MEMORANDUM
Community Development Department

Date: January 19, 2023
To: Planning Commission
From: Matthew Martin, Principal Planner
Subject: Deliberations: Sunset Meadows Master Plan - File Nos. MP 22-01/SUB 22-01/MNR 22-02

RE: Files no. MP 22-01/SUB 22-01/MNR 22-02 – **Revised Plan**

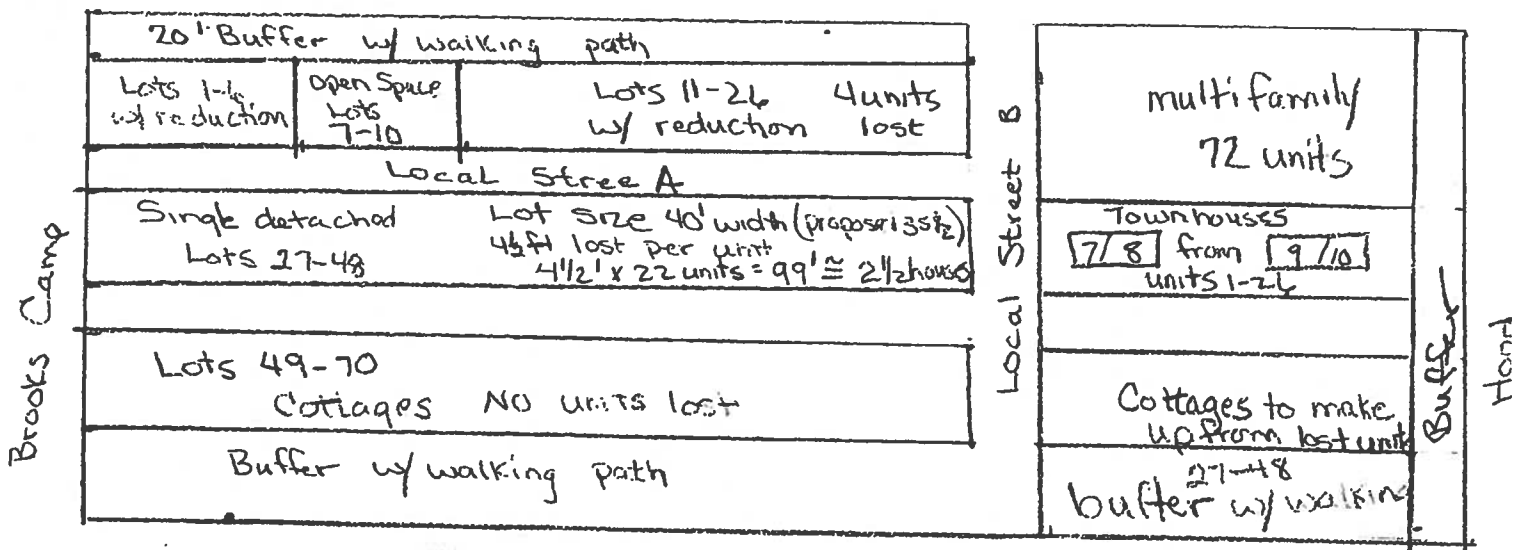
1. Keeping the asked reduction of lot sizes and replace the townhouses, lots 49-70, with cottages. This will reduce the wall feeling the townhouses will create along Hwy. 242. It would also allow views of the Sisters from lots 27-48 and perhaps views from the townhouses lots 1-26. This would eliminate the homes on lots 27-48 from being boxed in and give the development a more open feeling.

2. Keep units 27-48 but with NO lot size reduction. The "lost" units could be built on part of the lot proposed for multifamily, tract C.
3. Because townhouses (lots 49-70) are now cottages and the wall feeling is gone, shift the development 10 feet towards Hwy. 242 and add that 10 feet to the buffer between The Pines and Sunset Meadows for a buffer of 20 feet. This would also allow for a walking path to encircle the whole Sunset Meadows community. Plant trees to help buffer The Pines and Sunset Meadows.

4. Keep lots 1-26 as proposed (reduced lot size) but remove townhouses lots 7-10 for an open space, i.e. play area and dog area. These "lost" units could be built on part of the lot proposed for multifamily, tract C.

5. Keep the multifamily units (apartments) to the minimum proposed (72) and add "lost" townhouses and approximately 5-6 cottages or a couple duplexes to tract C. The cottages or duplexes would be aligned with the cottages on lots 49-70. The townhouses aligned the lots 27-48.

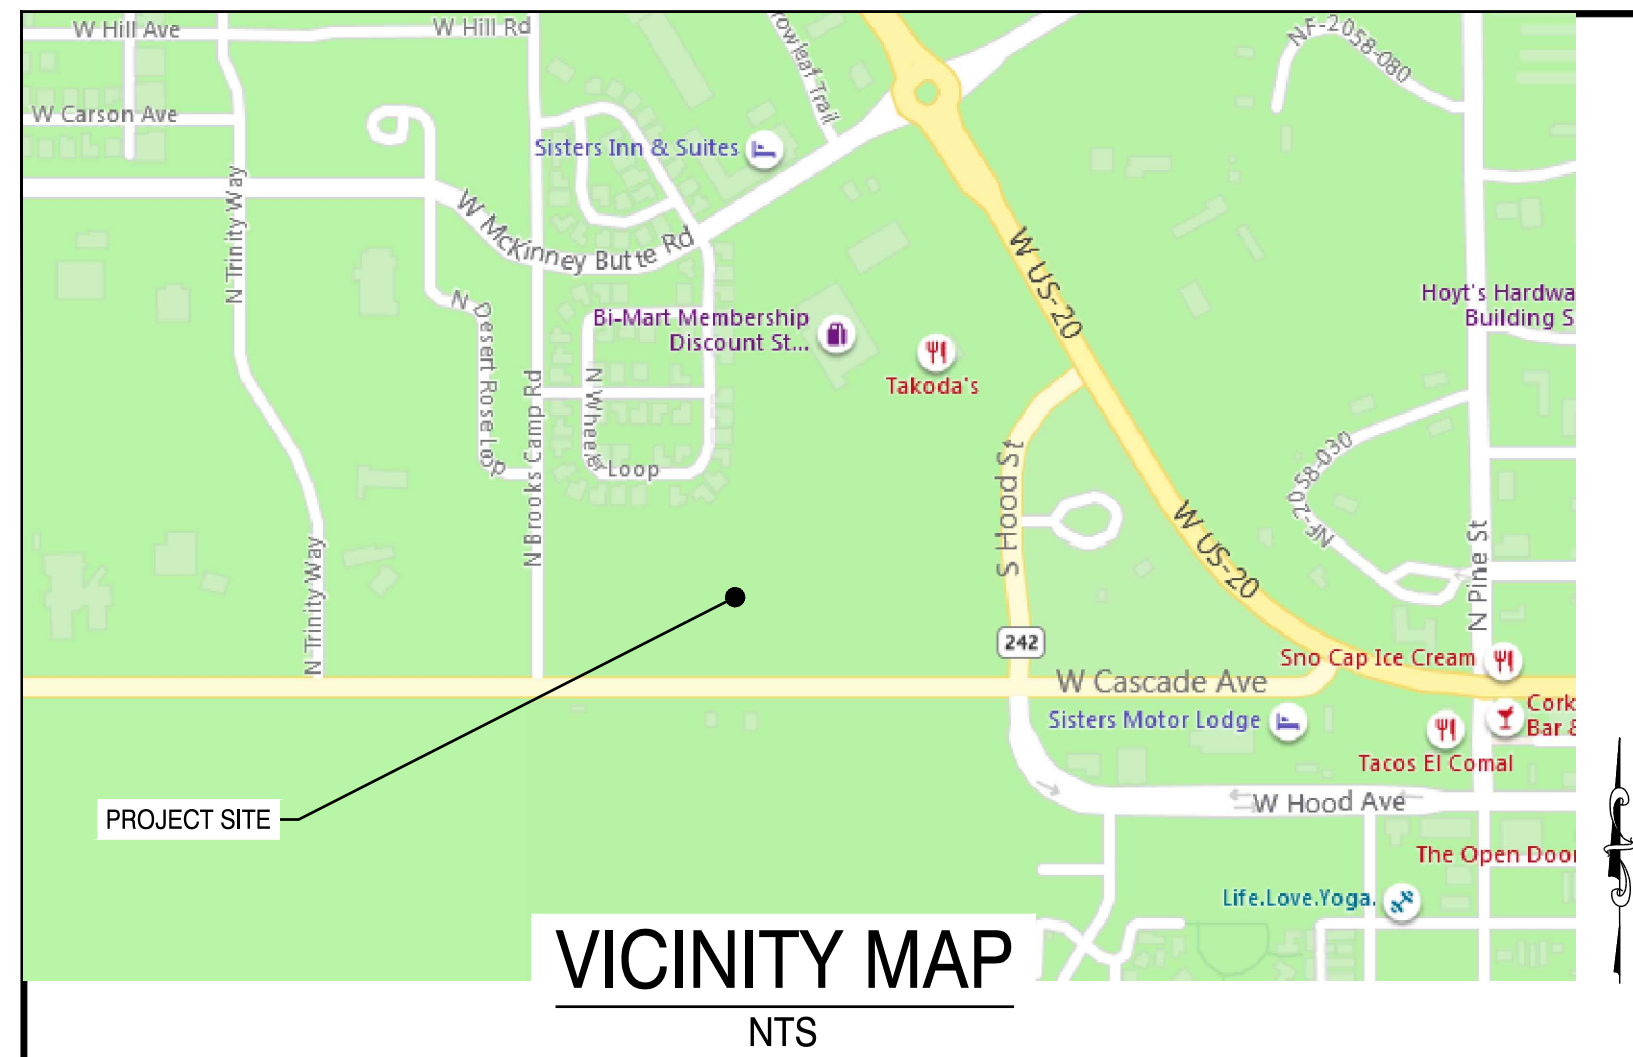
- The revised plan does not remove alley access for the north row of lots. Such a change could be considered a significant alteration to the proposal and may not be accepted under 4.1.700(E)(4). The proposed alley access removes the driveway/sidewalk conflict, improves pedestrian connectivity along Street A, and provides ample on-street parking along Street A for guests.
- The multifamily phase is designated as Phase 5, although the option still exists to develop the multifamily at any time. In the original plan and revised plan, the applicant included a partition application that allows the multifamily component to be separated into it's own parcel and be developed separately. The partition application allows financing the multifamily component sooner should it develop before Phase 5.
- The Sunset Meadows plan provides 30% open space, which is double the required standard.
